**ZONING AMENDMENT
& SUBDIVISION STAFF REPORT****Date: April 6, 2017****APPLICANT NAME**

5955 Airport Subdivision

5955 Airport Boulevard, 754 Linlen Avenue and 755 Pinemont Drive
(Southwest corner of Airport Boulevard and Linlen Avenue extending to the Southeast corner of Airport Boulevard and Pinement Drive).

Subdivision approval to create 1 lot, and Zoning approval to rezone the site from R-1, Single Family Residential District and B-2, Neighborhood Business District, to B-1, Buffer Business District, to eliminate split zoning.

PROPOSED SITE PLAN

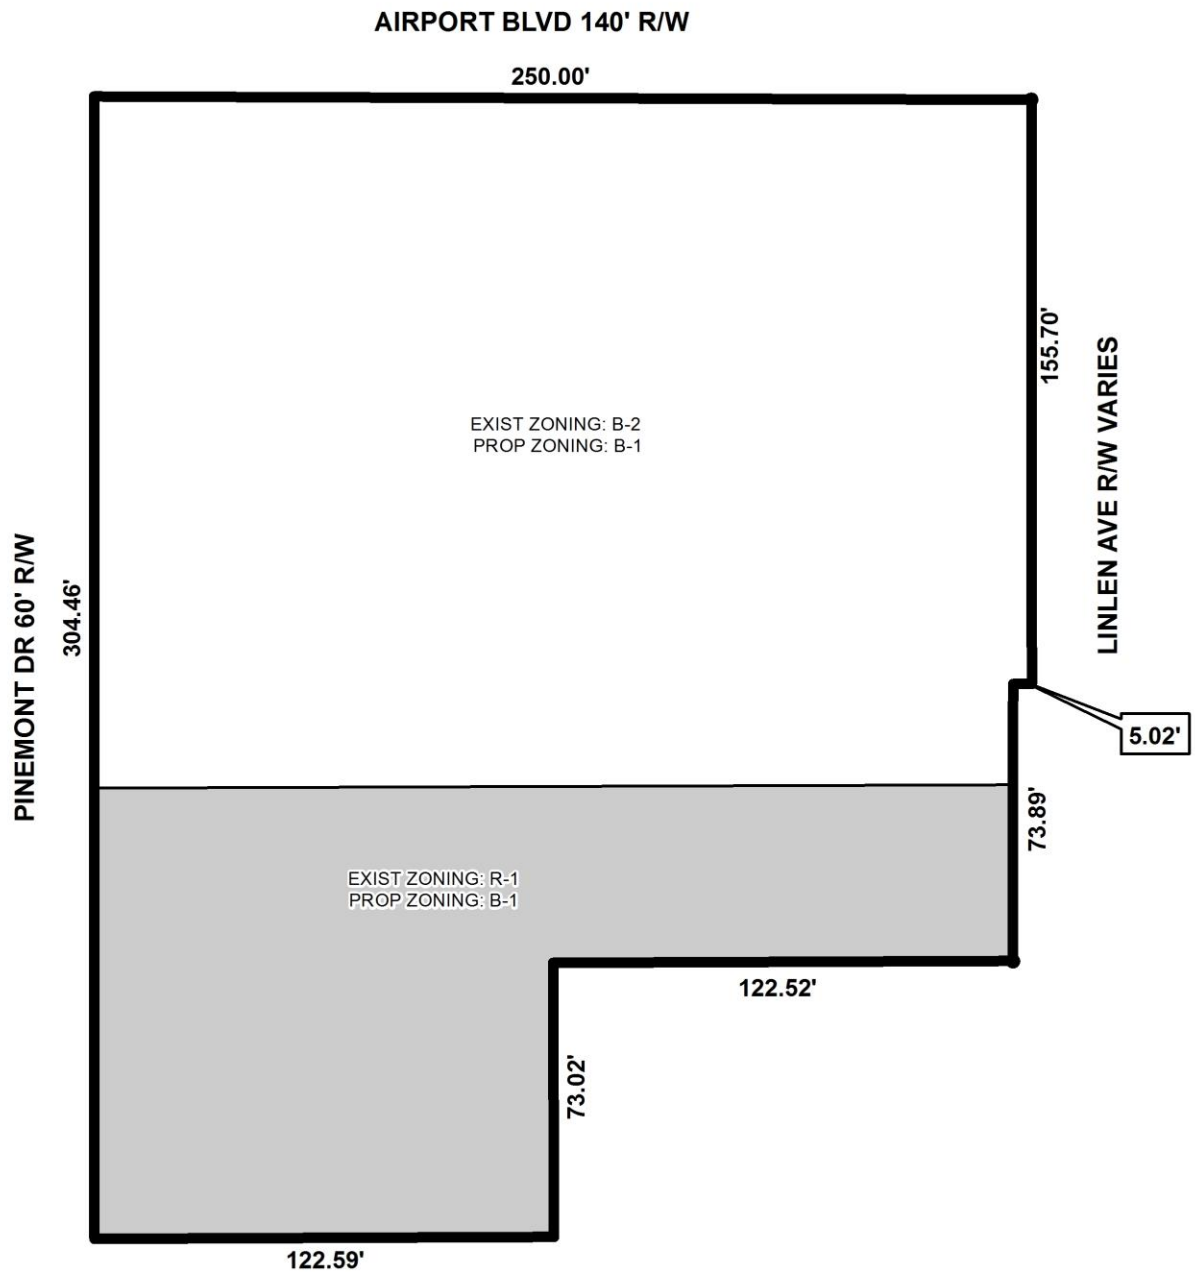
The site plan does not indicate the method of garbage collection for the subject site. The site plan should be revised to illustrate that onsite garbage collection will be served via a dumpster with a compliant enclosure and a connection to sanitary sewer in accordance with Section 64-4.D.9 of the Zoning Ordinance, or the placement of a note on the site plan indicating such. If a dumpster will not be provided, a note should be placed on the site plan stating that garbage collection will be provided via curbside or by private garbage collection services. Also, the revised site plan must ensure that the dumpster, if provided, is not any required setbacks.

The location and dimensions of the existing and/or proposed HVAC mechanical equipment for the proposed medical building structure is not illustrated on the site plan. The site plan should be revised to indicate the location, height and size of the HVAC mechanical equipment (i.e. HVAC units, generators, etc.) in compliance with Section 64-4.D.11 of the Zoning Ordinance.
